E-Series	Model Description	Production Date
G60	5 Series Sedan BEV	Vehicles produced up to December 1, 2023
G70	7 Series Sedan BEV

A drumming noise is heard when the air conditioning system is operating.

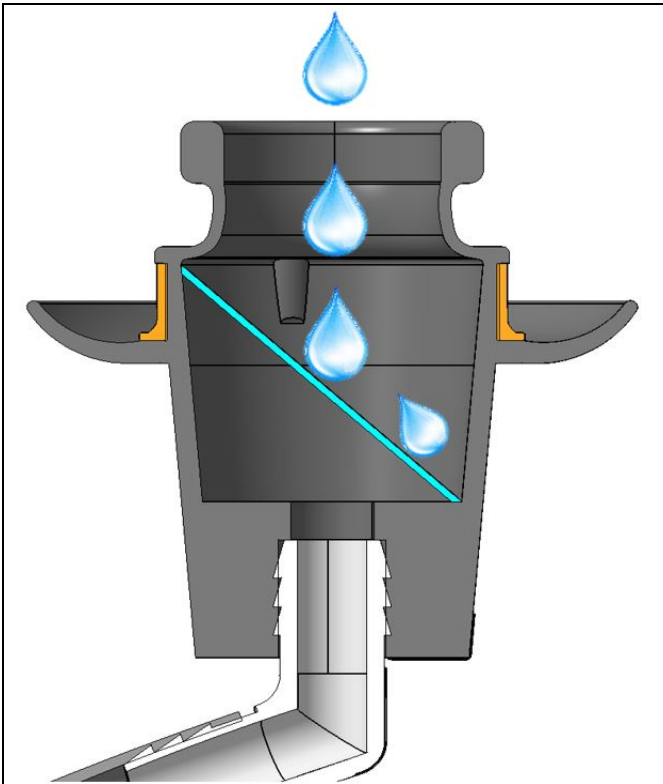
Water dripping into the condensate drain is heard echoing via the condensate drain pipe.

A ramp insert will be placed into the condensation drain plug, so the water drops falling into the condensate drain pipe are broken up eliminating the drumming noise.
